**CITY OF BOULDER**  
**PLANNING BOARD MEETING AGENDA**  
**DATE:** June 4, 2015  
**TIME:** 5 p.m.  
**PLACE:** 1777 Broadway, Council Chambers

- A. [Information Item](#): Floodplain mapping revisions for Skunk Creek, Bluebell Canyon Creek and King's Gulch

**DATE:** February 5, 2015 **ACE PROJECT NO.:** COBLDR16  
**TO:** Katie Knapp, City of Boulder Planning and Development Department  
**FROM:** Brian Van Zanten, Anderson Consulting Engineers, Inc. *BLV*  
Greg Koch, Anderson Consulting Engineers, Inc. *GTK*  
**SUBJECT:** Peer Review – Skunk Creek, Bluebell Canyon Creek, and King’s Gulch Request for Physical Map Revision Report, Boulder, Colorado

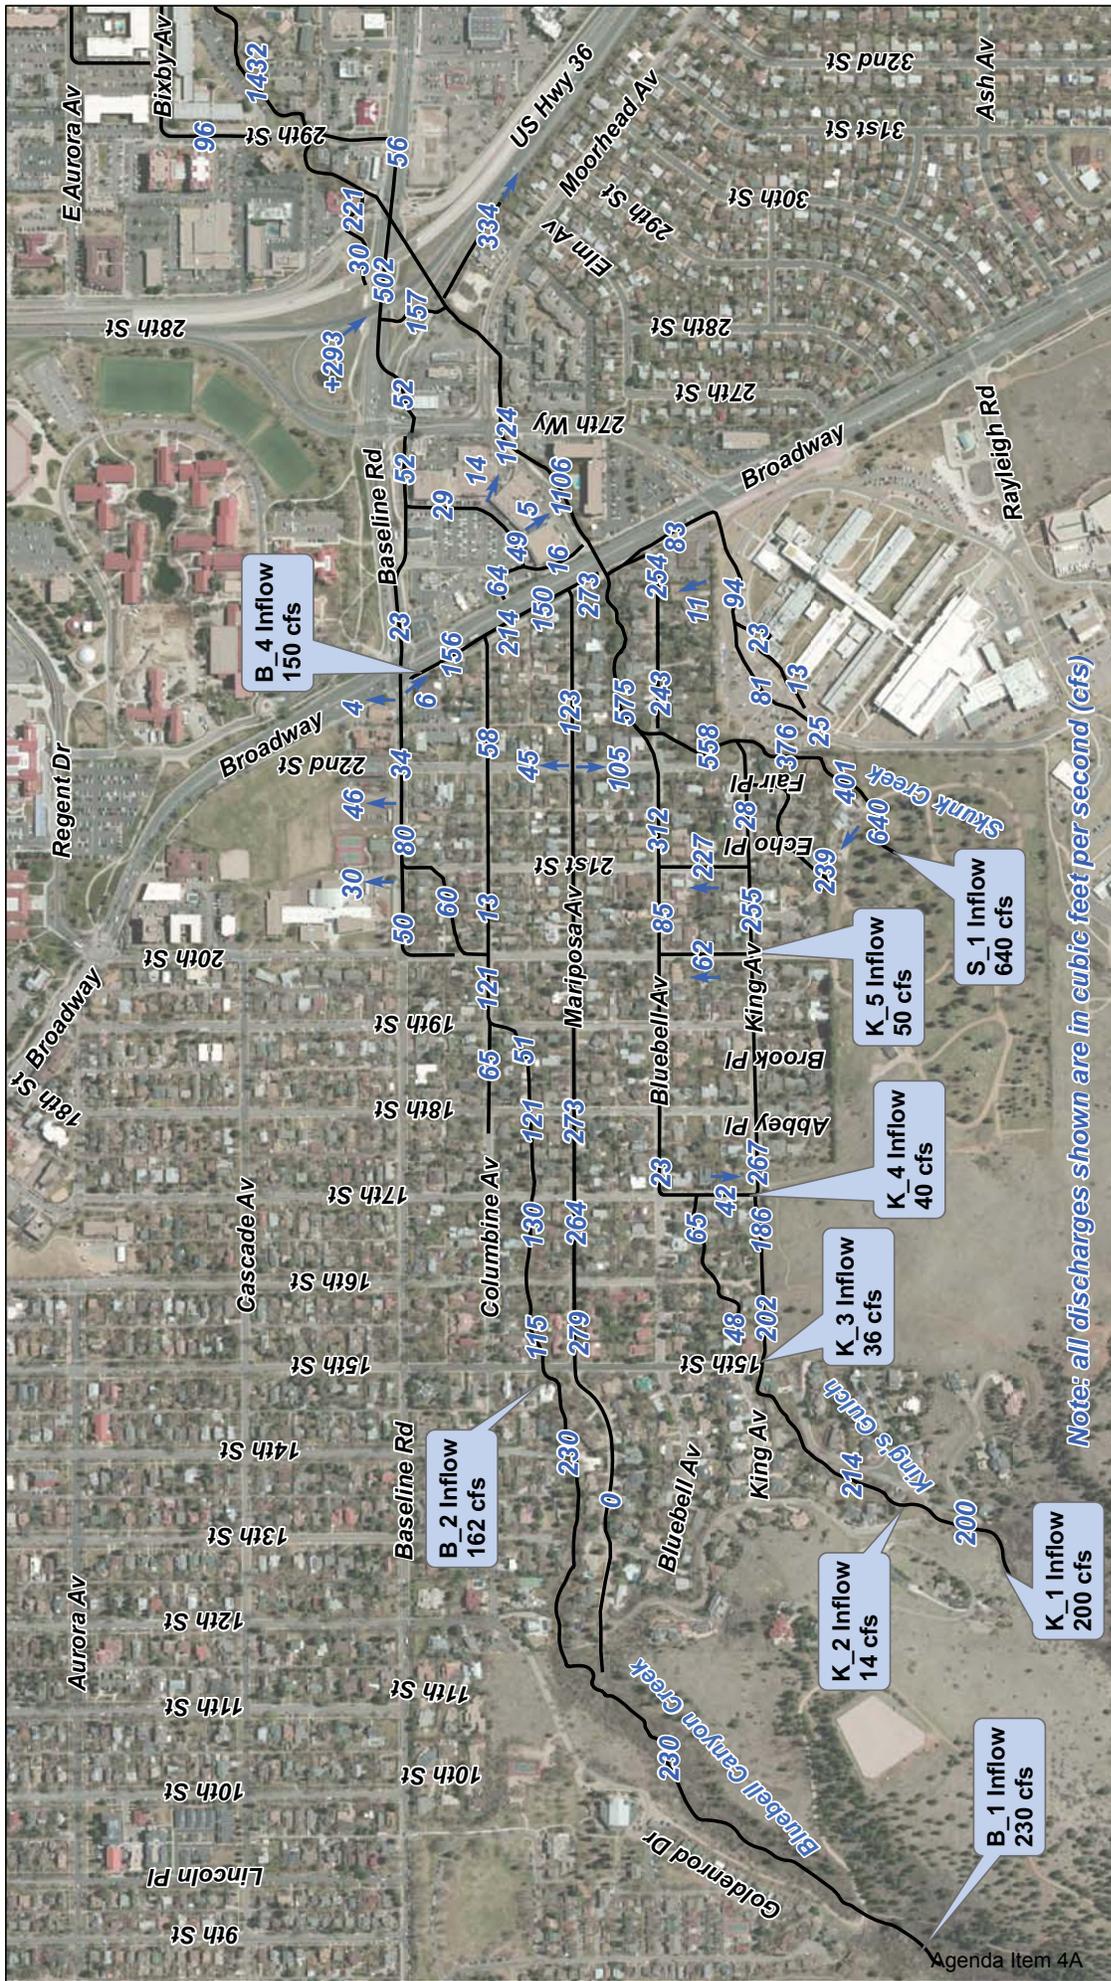
**63. Please add flow path identification on the work maps.**

Separate flow path identification work maps have been prepared. Please see figures 4 and 5.
